Responses to Comments on the Draft EA

On November 18, 2019, the FAA released the Draft Environmental Assessment (EA) for the proposed Las Vegas Metroplex Project for public review and comment. The comment period ran for 64 days and closed on January 21, 2020. The FAA recognizes the importance and value of public input in this process.

Figure 1: GIDGT/RATPK Extended to Blue Diamond Road

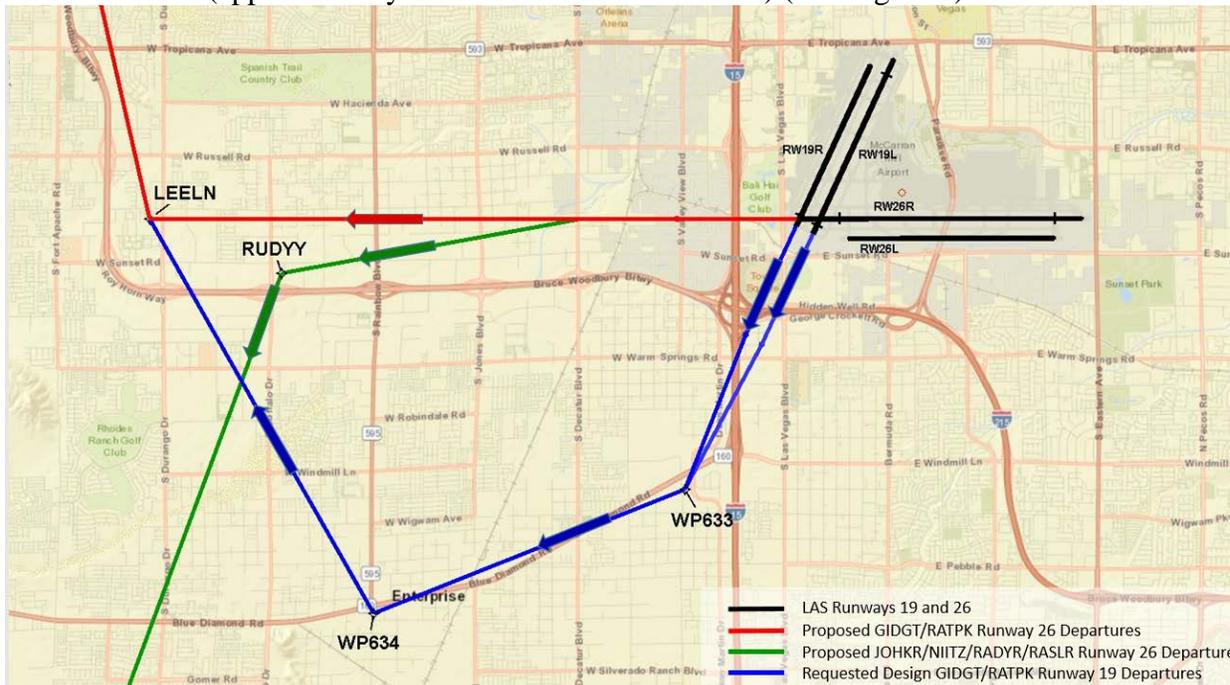
The FAA evaluated a design that delayed making a right turn to LEELN until crossing Blue Diamond Road (approximately 2.5 miles southwest of LAS) (See Figure 1).

The FAA determined that in addition to the criteria failures, the suggested route over Blue Diamond Road would reduce efficiency due to increased delays for departures from separate runways and increase miles flown. Also, extension of the RATPK and GIDGT departure procedures could present a situation where LAS Runway 19 departures would be routed nearly head on toward aircraft on LAS JOHKR, NIITZ, RASLR and RAYDR departure procedures departing LAS Runway 26 (See Figure 1).

Figure 1: GIDGT/RATPK Extended to Blue Diamond Road

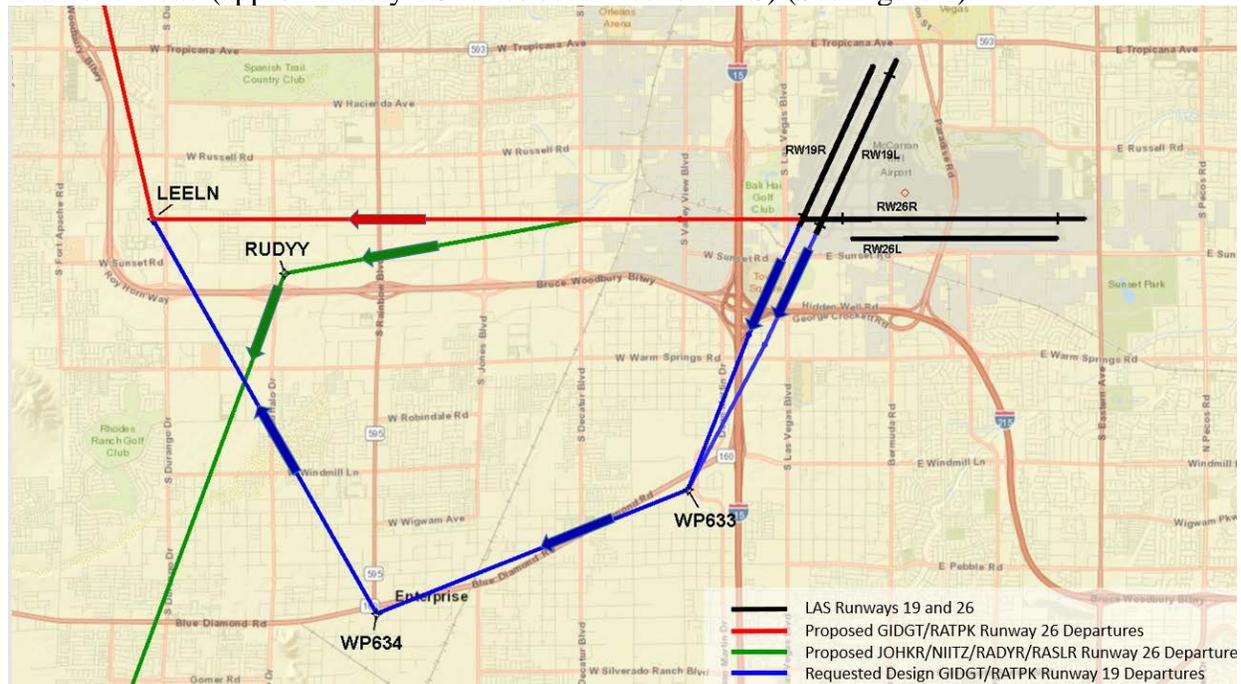
The FAA evaluated a design that delayed making a right turn to LEELN until crossing Blue Diamond Road (approximately 2.5 miles southwest of LAS) (See Figure 1).

The FAA determined that in addition to the criteria failures, the suggested route over Blue Diamond Road would reduce efficiency due to increased delays for departures from separate runways and increase miles flown. Also, extension of the RATPK and GIDGT departure procedures could present a situation where LAS Runway 19 departures would be routed nearly head on toward aircraft on LAS JOHKR, NIITZ, RASLR and RAYDR departure procedures departing LAS Runway 26 (See Figure 1).

Figure 1: GIDGT/RATPK Extended to Blue Diamond Road

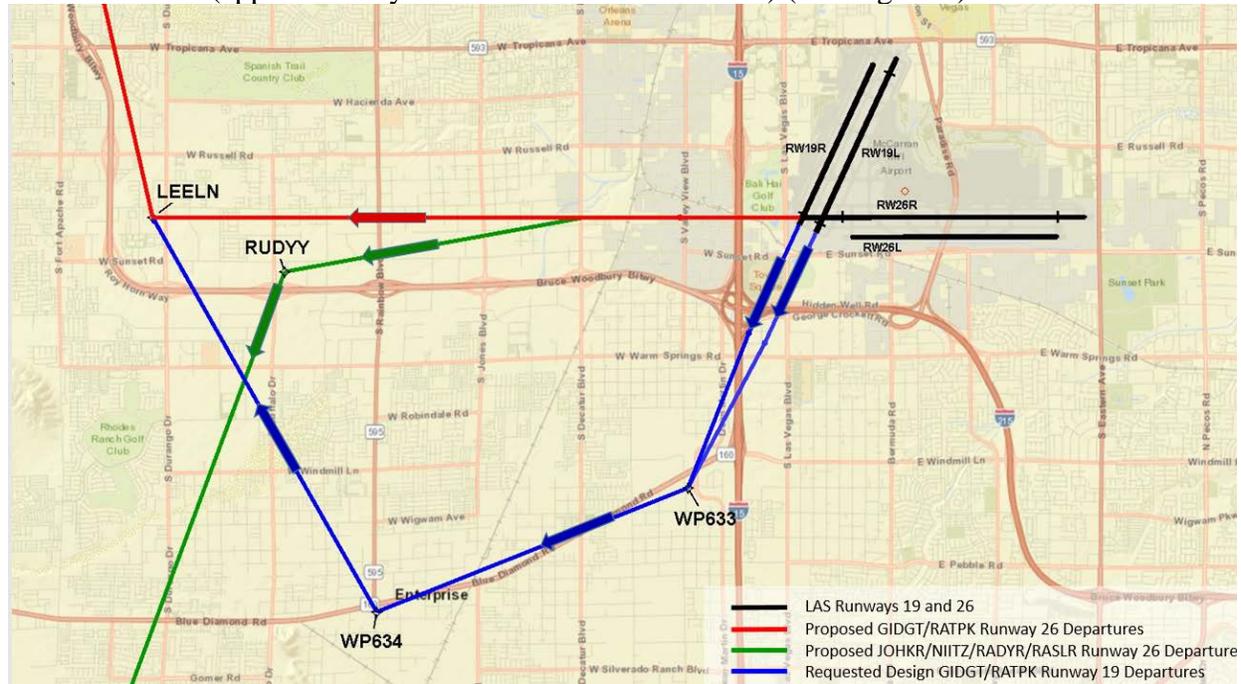
The FAA evaluated a design that delayed making a right turn to LEELN until crossing Blue Diamond Road (approximately 2.5 miles southwest of LAS) (See Figure 1).

The FAA determined that in addition to the criteria failures, the suggested route over Blue Diamond Road would reduce efficiency due to increased delays for departures from separate runways and increase miles flown. Also, extension of the RATPK and GIDGT departure procedures could present a situation where LAS Runway 19 departures would be routed nearly head on toward aircraft on LAS JOHKR, NIITZ, RASLR and RAYDR departure procedures departing LAS Runway 26 (See Figure 1).

Figure 1: GIDGT/RATPK Extended to Blue Diamond Road

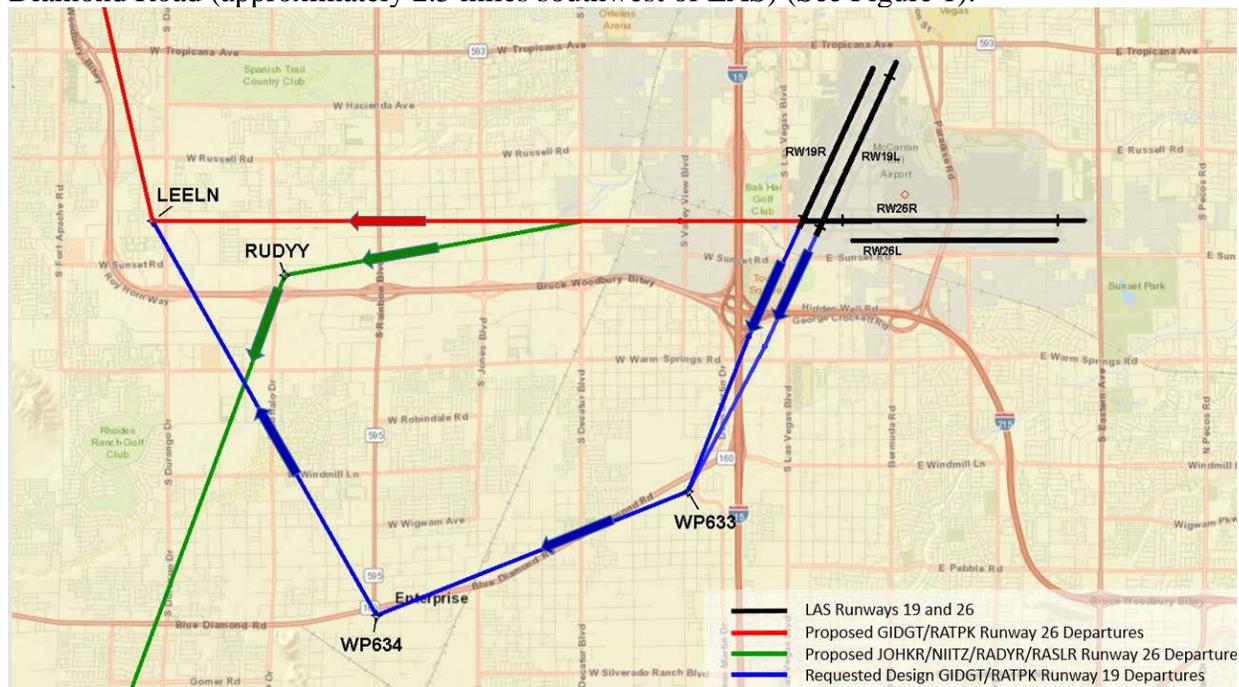
The FAA evaluated a design that delayed making a right turn to LEELN until crossing Blue Diamond Road (approximately 2.5 miles southwest of LAS) (See Figure 1).

The FAA determined that in addition to the criteria failures, the suggested route over Blue Diamond Road would reduce efficiency due to increased delays for departures from separate runways and increase miles flown. Also, extension of the RATPK and GIDGT departure procedures could present a situation where LAS Runway 19 departures would be routed nearly head on toward aircraft on LAS JOHKR, NIITZ, RASLR and RAYDR departure procedures departing LAS Runway 26 (See Figure 1).

Figure 1: GIDGT/RATPK Extended to Blue Diamond Road

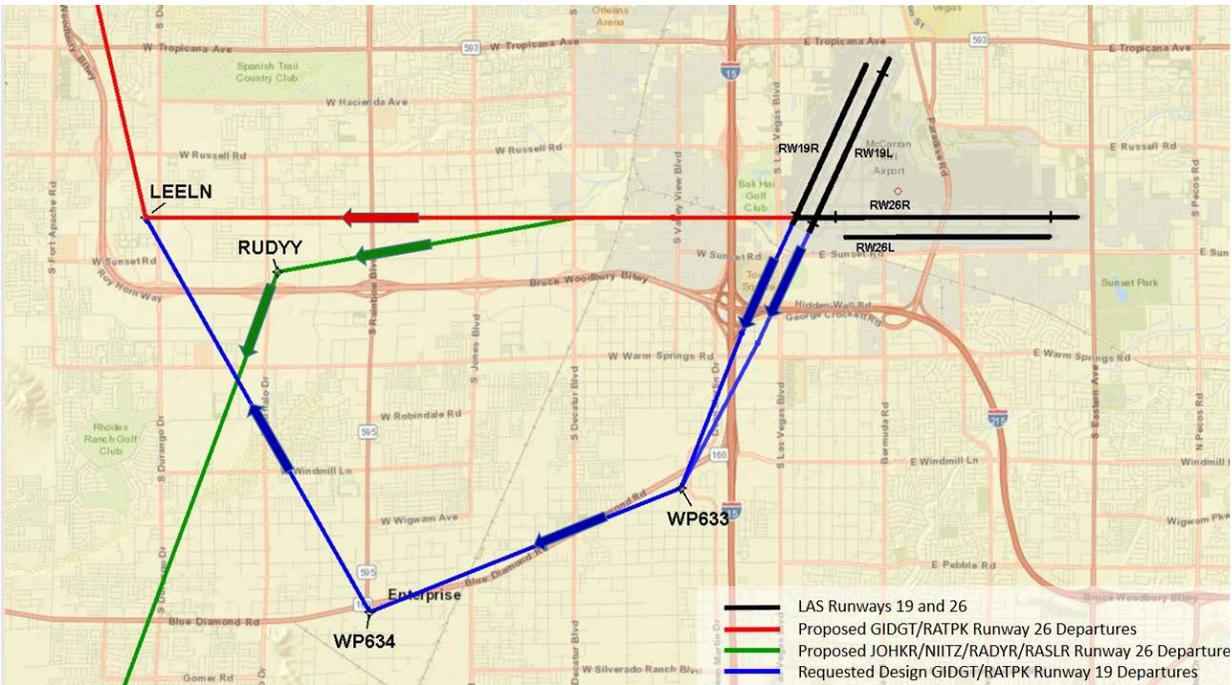
The FAA evaluated a design that delayed making a right turn to LEELN until crossing Blue Diamond Road (approximately 2.5 miles southwest of LAS) (See Figure 1).

The FAA determined that in addition to the criteria failures, the suggested route over Blue Diamond Road would reduce efficiency due to increased delays for departures from separate runways and increase miles flown. Also, extension of the RATPK and GIDGT departure procedures could present a situation where LAS Runway 19 departures would be routed nearly head on toward aircraft on LAS JOHKR, NIITZ, RASLR and RAYDR departure procedures departing LAS Runway 26 (See Figure 1).

Figure 1: GIDGT/RATPK Extended to Blue Diamond Road

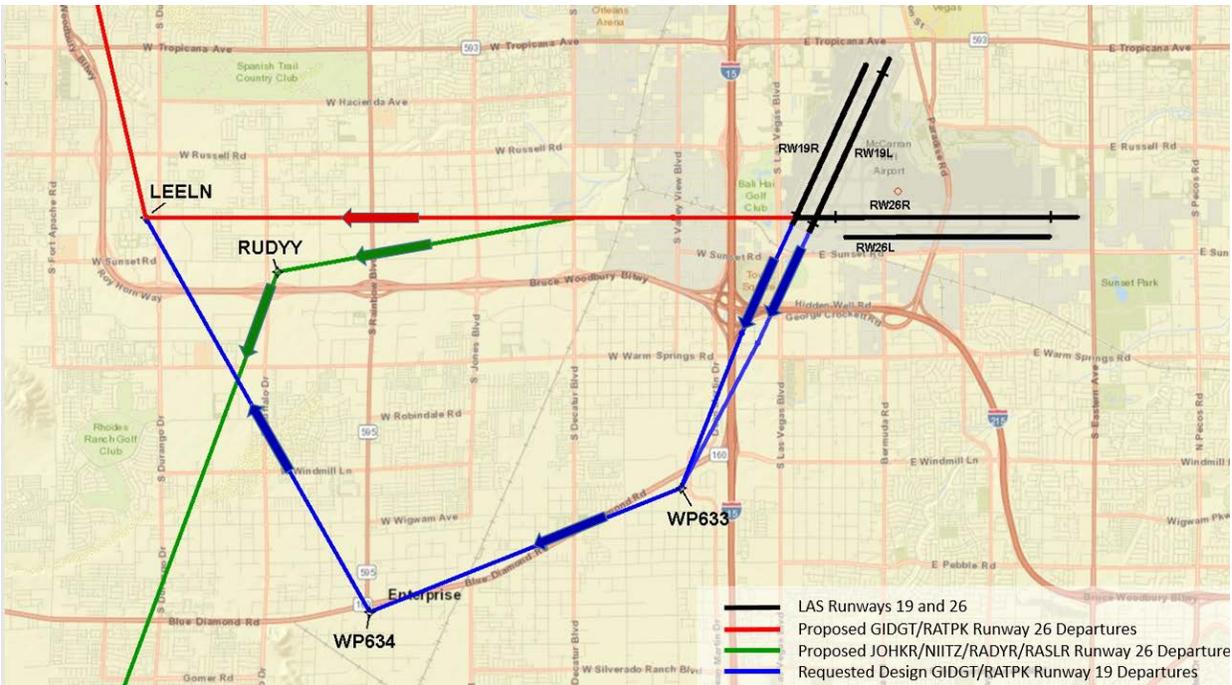
The FAA evaluated a design that delayed making a right turn to LEELN until crossing Blue Diamond Road (approximately 2.5 miles southwest of LAS) (See Figure 1).

The FAA determined that in addition to the criteria failures, the suggested route over Blue Diamond Road would reduce efficiency due to increased delays for departures from separate runways and increase miles flown. Also, extension of the RATPK and GIDGT departure procedures could present a situation where LAS Runway 19 departures would be routed nearly head on toward aircraft on LAS JOHKR, NIITZ, RASLR and RAYDR departure procedures departing LAS Runway 26 (See Figure 1).

Figure 1: GIDGT/RATPK Extended to Blue Diamond Road

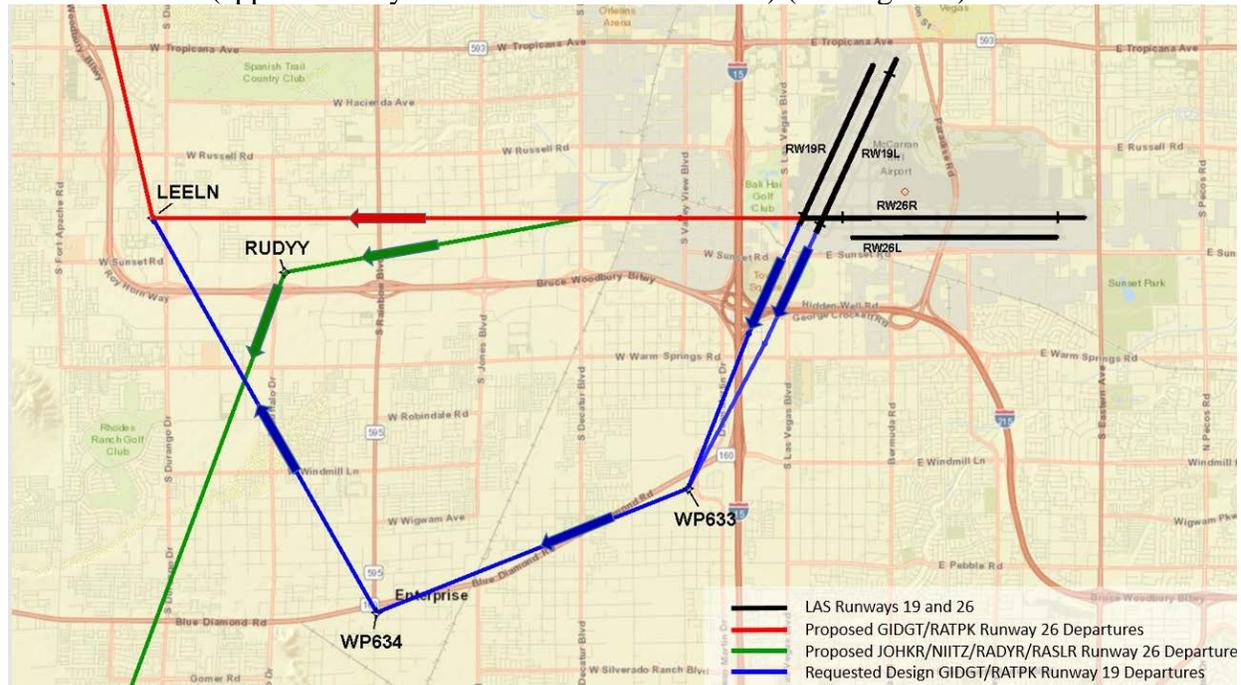
The FAA evaluated a design that delayed making a right turn to LEELN until crossing Blue Diamond Road (approximately 2.5 miles southwest of LAS) (See Figure 1).

The FAA determined that in addition to the criteria failures, the suggested route over Blue Diamond Road would reduce efficiency due to increased delays for departures from separate runways and increase miles flown. Also, extension of the RATPK and GIDGT departure procedures could present a situation where LAS Runway 19 departures would be routed nearly head on toward aircraft on LAS JOHKR, NIITZ, RASLR and RAYDR departure procedures departing LAS Runway 26 (See Figure 1).

Figure 1: GIDGT/RATPK Extended to Blue Diamond Road

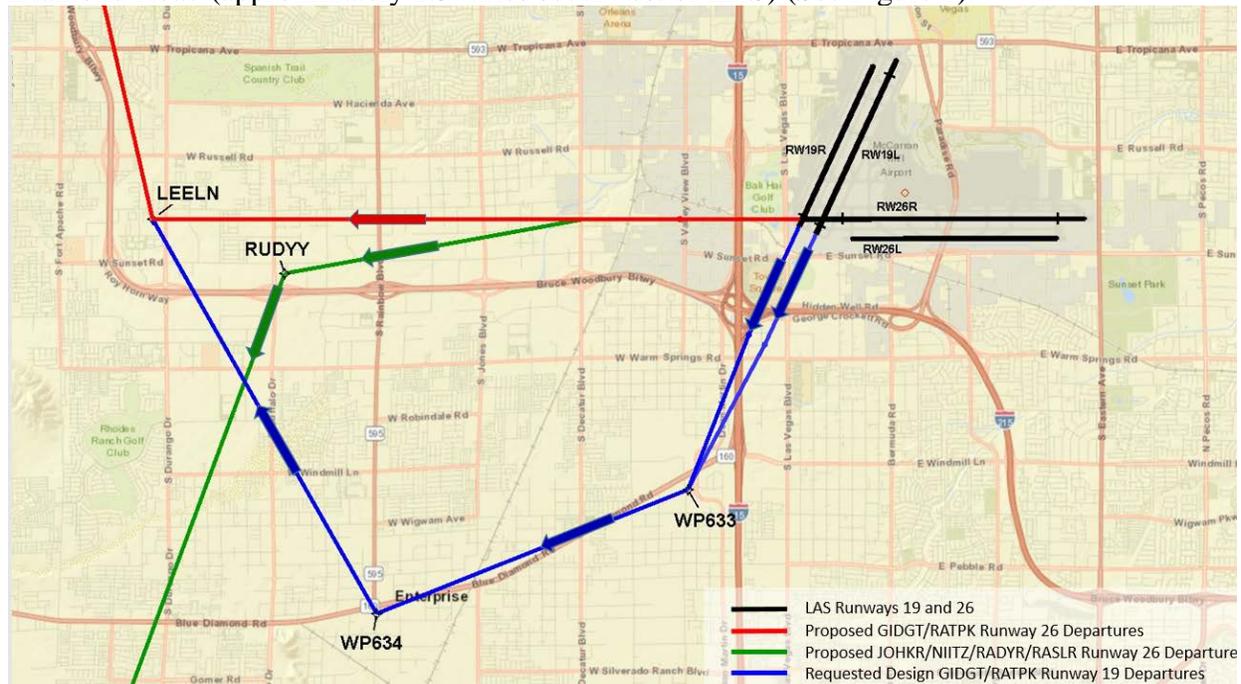
The FAA evaluated a design that delayed making a right turn to LEELN until crossing Blue Diamond Road (approximately 2.5 miles southwest of LAS) (See Figure 1).

The FAA determined that in addition to the criteria failures, the suggested route over Blue Diamond Road would reduce efficiency due to increased delays for departures from separate runways and increase miles flown. Also, extension of the RATPK and GIDGT departure procedures could present a situation where LAS Runway 19 departures would be routed nearly head on toward aircraft on LAS JOHKR, NIITZ, RASLR and RAYDR departure procedures departing LAS Runway 26 (See Figure 1).

Figure 1: GIDGT/RATPK Extended to Blue Diamond Road

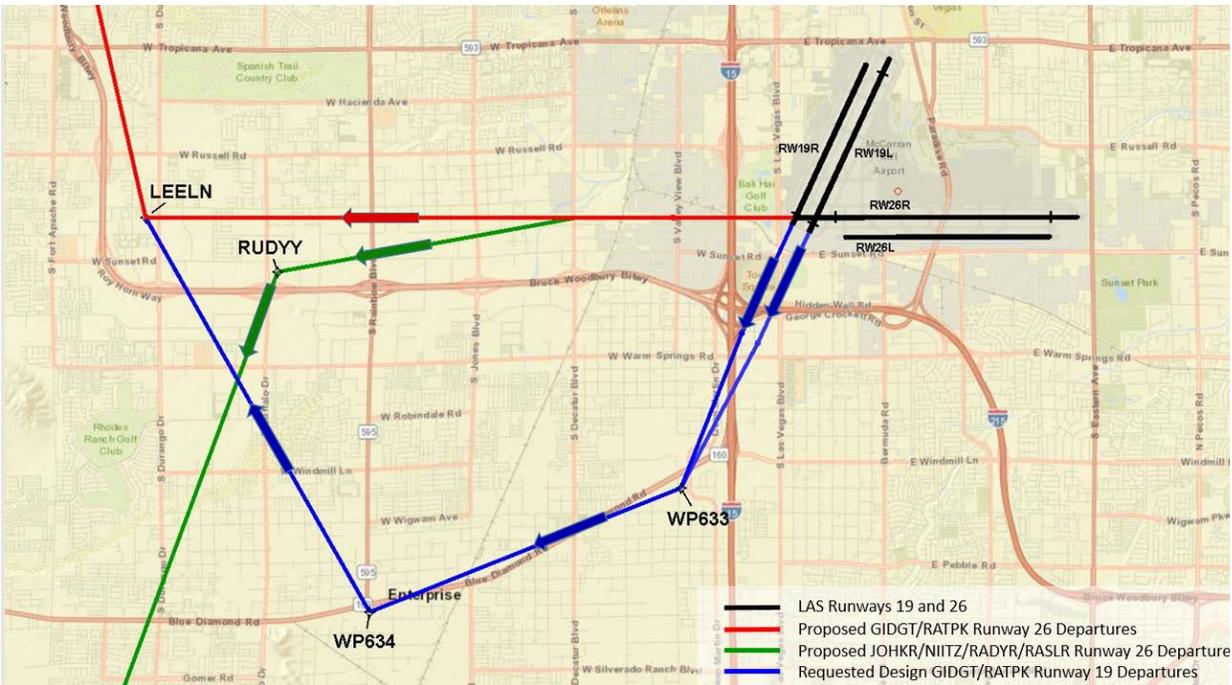
The FAA evaluated a design that delayed making a right turn to LEELN until crossing Blue Diamond Road (approximately 2.5 miles southwest of LAS) (See Figure 1).

The FAA determined that in addition to the criteria failures, the suggested route over Blue Diamond Road would reduce efficiency due to increased delays for departures from separate runways and increase miles flown. Also, extension of the RATPK and GIDGT departure procedures could present a situation where LAS Runway 19 departures would be routed nearly head on toward aircraft on LAS JOHKR, NIITZ, RASLR and RAYDR departure procedures departing LAS Runway 26 (See Figure 1).

Figure 1: GIDGT/RATPK Extended to Blue Diamond Road

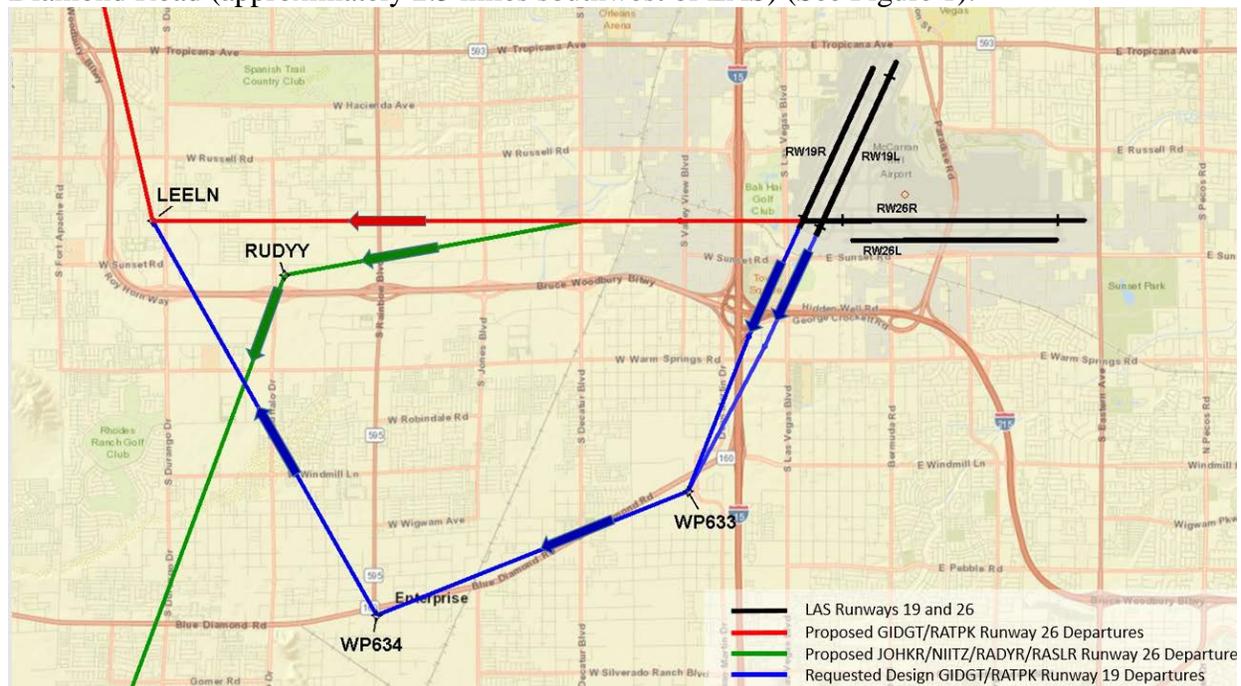
The FAA evaluated a design that delayed making a right turn to LEELN until crossing Blue Diamond Road (approximately 2.5 miles southwest of LAS) (See Figure 1).

The FAA determined that in addition to the criteria failures, the suggested route over Blue Diamond Road would reduce efficiency due to increased delays for departures from separate runways and increase miles flown. Also, extension of the RATPK and GIDGT departure procedures could present a situation where LAS Runway 19 departures would be routed nearly head on toward aircraft on LAS JOHKR, NIITZ, RASLR and RAYDR departure procedures departing LAS Runway 26 (See Figure 1).

Figure 1: GIDGT/RATPK Extended to Blue Diamond Road

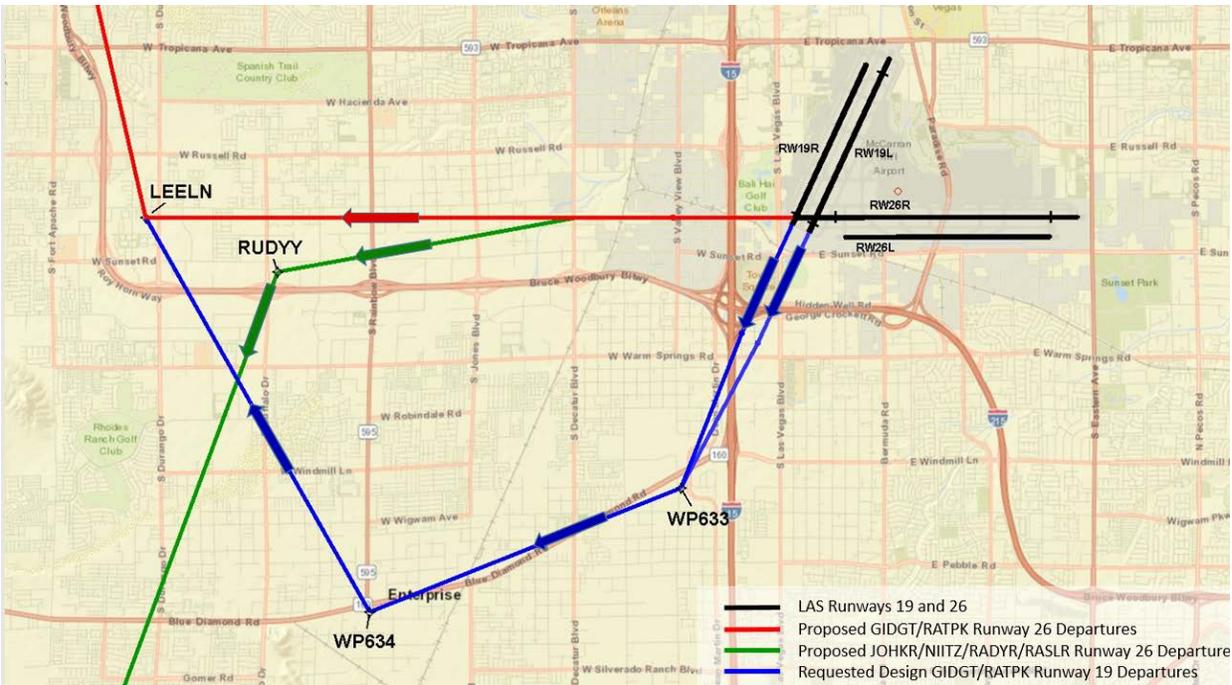
The FAA evaluated a design that delayed making a right turn to LEELN until crossing Blue Diamond Road (approximately 2.5 miles southwest of LAS) (See Figure 1).

The FAA determined that in addition to the criteria failures, the suggested route over Blue Diamond Road would reduce efficiency due to increased delays for departures from separate runways and increase miles flown. Also, extension of the RATPK and GIDGT departure procedures could present a situation where LAS Runway 19 departures would be routed nearly head on toward aircraft on LAS JOHKR, NIITZ, RASLR and RAYDR departure procedures departing LAS Runway 26 (See Figure 1).
